Flat A 15 Well Walk 2016/6491/P

I am commenting on aspects of this application as they relate to trees and to groundwater.

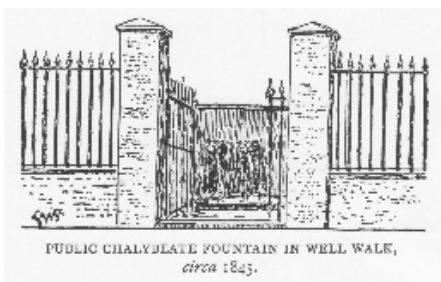
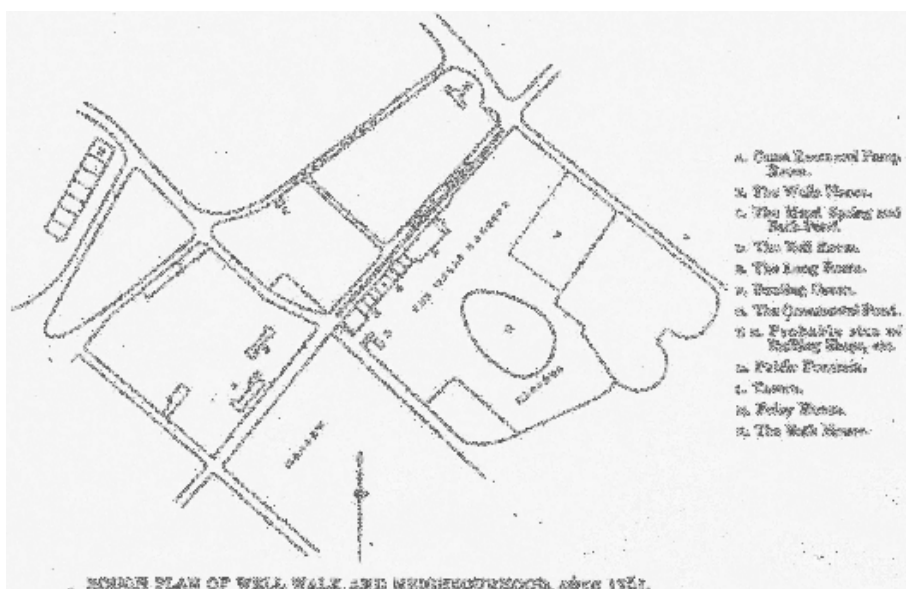
Far from it. This is a known spring line.

This c1761 map of the immediate area demonstrates the practical use being made of the local springs in the past. While some of this water was piped then and is now, there is still evidence of other groundwater and springs.

1866 OS map showing large pond downstream of 15 Well Walk

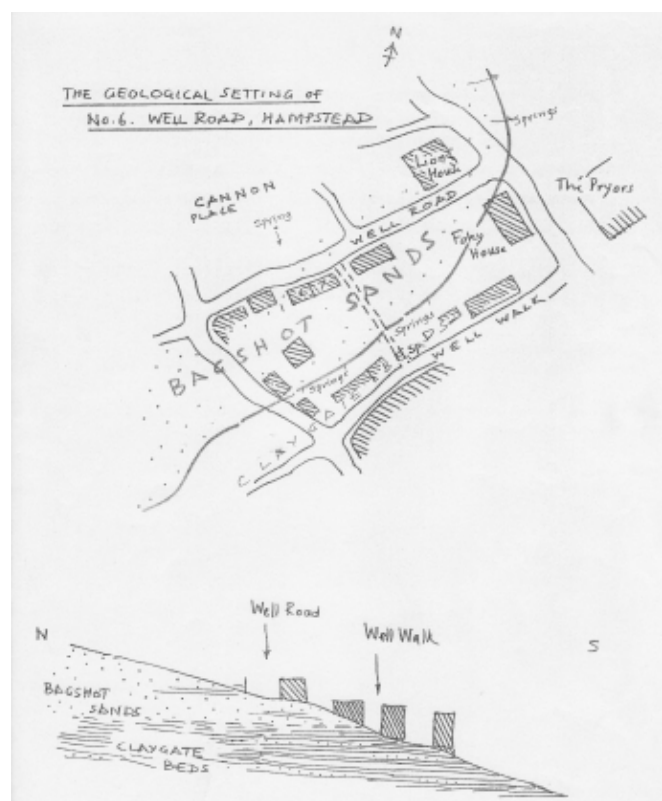
The 1761 map and 1866 OS map of the area show the large pond where Gainsborough Gardens now are, originally fed by a spring originating in Well Road, later directed via a conduit running below Wells passage (that

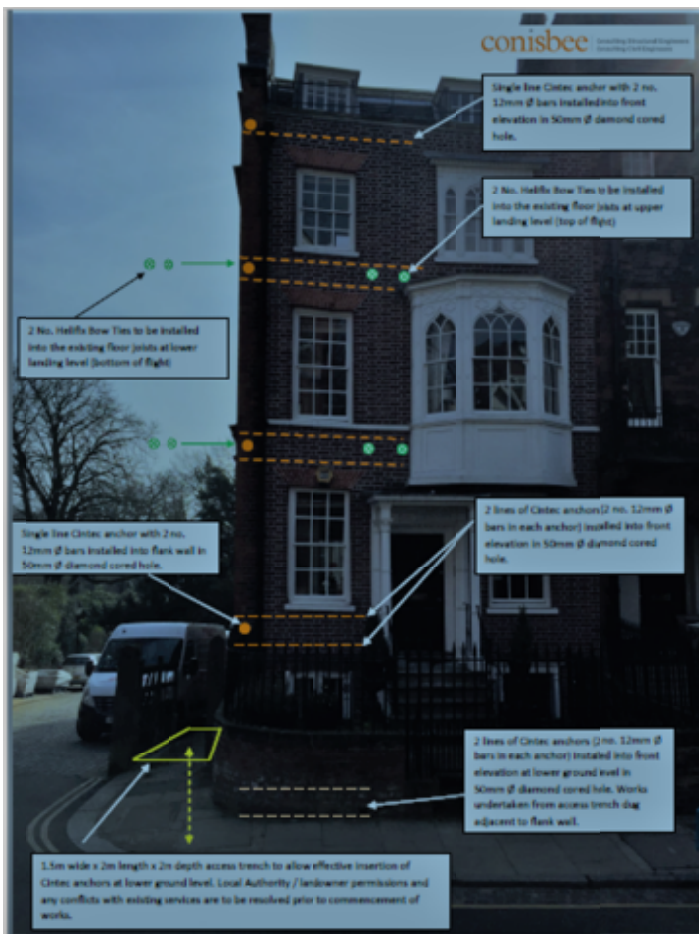
No mention is made at all of the notorious silt erosion that occurs throughout much of the Hampstead area.

Some of the groundwater still running below houses on even moderate slopes can affect them by contributing to ground slip, but its main action is erosion of the significant proportion of silt within the Claygate Beds causing subsidence. Number 46 Well Walk for example – almost directly opposite 15 Well Walk – is having underpinning work to strengthen it and withstand the sub-foundation volume loss from silt erosion by groundwater action. Movement monitoring from 2013 presented in 2016/0242/P showed that ongoing movement *was active*. Looking at 46 Well Walk from the road it can be seen that the main groundwater flow is below the house, west of the front door. This is in line with the eastern side of Wells Passage and thus closely associated with 15 Well Walk.
